Access Compliance Report

Public Rights-of-Way

(Curb Ramps)

Intersection ID: 12937	Main Street: E_W_T_HARRIS_BV	Cross Street: HICKORY_GROVE_RD	Location: SW
ADA ID: 3F18A737E2C5	Ramp Type: Perp	Initial Pass/Fail: Fail	Overall Compliance: No
Codes/Mitigation Info/Possible Solution		Field Measurements/Component Compliance

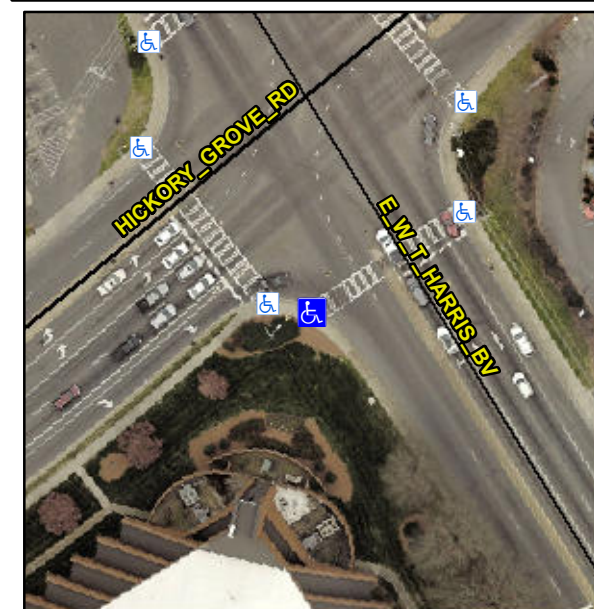
Not Found, R304.5.1, R304.2.2

Compliance	Description	Data	Compliance	Description	Data
N/A	Ramp Length (in)	25.0	No	Ramp Slope (%)	15.1
No	Ramp Width (in)	45.5	Yes	Ramp XSlope (%)	1.8
N/A	Flare Type LT	N/A	N/A	Flare Type RT	N/A
N/A	Flare Slope LT (%)	N/A	N/A	Flare Slope RT (%)	N/A
N/A	Flare Traversable LT?	N/A	N/A	Flare Traversable RT?	N/A
N/A	Landing Length (in)	N/A	N/A	DWS Provided?	N/A
N/A	Landing Width (in)	N/A	N/A	DWS Contrast?	N/A
N/A	Landing Slope (%)	N/A	N/A	DWS Length (in)	N/A
N/A	Landing X Slope (%)	N/A	N/A	DWS Full Width?	N/A
N/A	Landing Curb? (Y/N)	N/A	N/A	DWS Offset (in)	N/A
N/A	Shared Landing?	N/A			
N/A	Gutter Ponding?	N/A	N/A	Gutter Slope (%)	N/A
N/A	Gutter Lip Ht (in)	N/A	N/A	Gutter X Slope (%)	N/A
N/A	Painted X Walk1?	Yes	N/A	Painted X Walk2?	N/A
	X Walk 1 Direction	To E		X Walk 2 Direction	N/A
N/A	X Walk 1 Width (in)	115.0	N/A	X Walk 2 Width (in)	N/A
	X Walk 1 Slope (%)	1.6		X Walk 2 Slope (%)	N/A
	X Walk 1 X Slope (%)	1.2		X Walk 2 X Slope (%)	N/A

Remove & Replace Entire Ramp.
